Docket Item # 8
BAR CASE # 2008-0053

BAR Meeting
July 30, 2008

ISSUE: Alterations
APPLICANT: Rosemary Furfaro and James Woods
LOCATION: 511 Queen Street
ZONE: RM/Residential

Figure 4. Proposed site plan, fence and trellis.

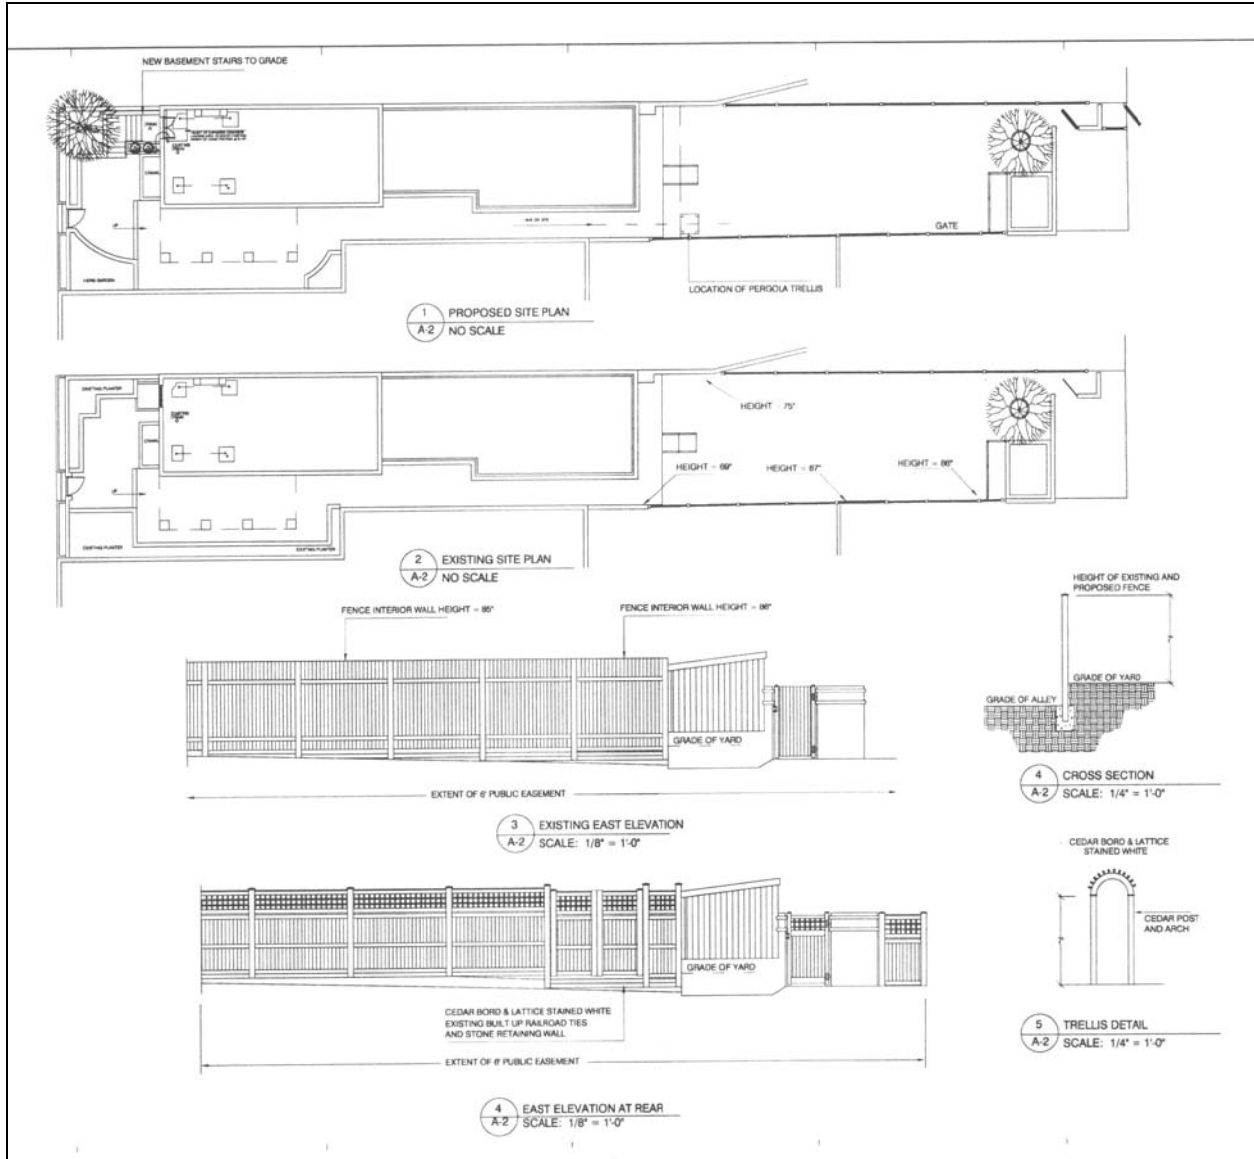
The existing wood fence is in a deteriorated condition and nearly covered in vegetation. The existing fence sits atop railroad ties on the east elevation along a utility easement. Due to the heavy overgrowth, the railroad ties are not easily visible at this time. The height of the existing wood fence and railroad ties ranges from 8' to 8.5'. The board and lattice fence is proposed to be 7' in height and constructed on top of the existing railroad ties. As a result, the height will range from 7.5' to 8' on the east elevation. Staff has strong concerns regarding the construction of what will mostly be an 8' fence.

The applicant has explained that the grade of the rear yard is approximately 1½ -2' higher than the surrounding grade at the alley. While, staff understands the desire to have a fence at least six feet in height in the interior of the yard, the BAR's purview is what is visible from the public right-of-way. Staff does not find a compelling reason for approving what will amount to an eight foot fence. There is no architectural or historic reasoning to approve such a height. However, recognizing the grade difference, staff considers that a board fence with open lattice top, reduced to six feet overall but still allowed to be installed on the existing railroad ties, would be the most acceptable option.

The proposed trellis located at the rear of the upper patio features an arch with decorative knobs. The proposed height (as measured from the drawings submitted) will be approximately 9' in height and 11' above the alley grade. Again, staff is concerned regarding this height. Staff recommends the trellis height be reduced by at least one foot.

Staff has no objections to the proposed trash enclosure provided that the fence is no taller than six feet.

1. That the proposed fence shall not exceed 6 feet in height (but may be installed upon the existing railroad ties) and that the applicant shall provide specifications to staff of the proposed fence for approval prior to its installation;
2. That the proposed trellis be reduced in height by at least one foot from approximately 9 feet to 8 feet; and,
3. That the applicant shall provide staff with an alternate lantern that is more historically appropriate for final approval.

Figure 6. Details of proposed lantern and lattice fence.

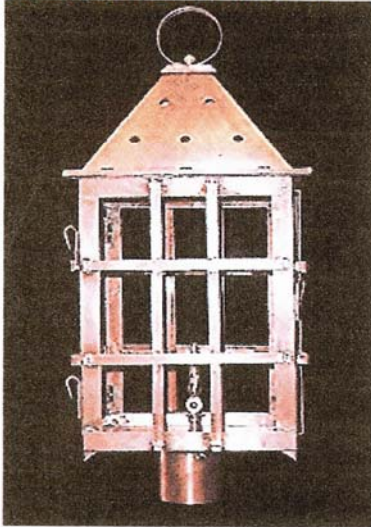
The applicant should bring a cut sheet of the proposed fence design to staff for approval prior to installation. Staff supports the proposed fence design reduced to six feet and installed on the existing railroad ties.

Staff has concerns regarding the design of the lantern that is out of character with other lighting fixtures in the district. The lighting appears to be too heavy in form and medieval or Tudor in character, making it inappropriate for this 18th-century dwelling. In addition, the proposed height and size of the lanterns will be prominent on the front brick wall, making it advisable to have a more appropriate design. One alternative would be to remove the grills on the faces of the lantern. Staff requests that the applicant propose a more historically appropriate lantern for staff approval.
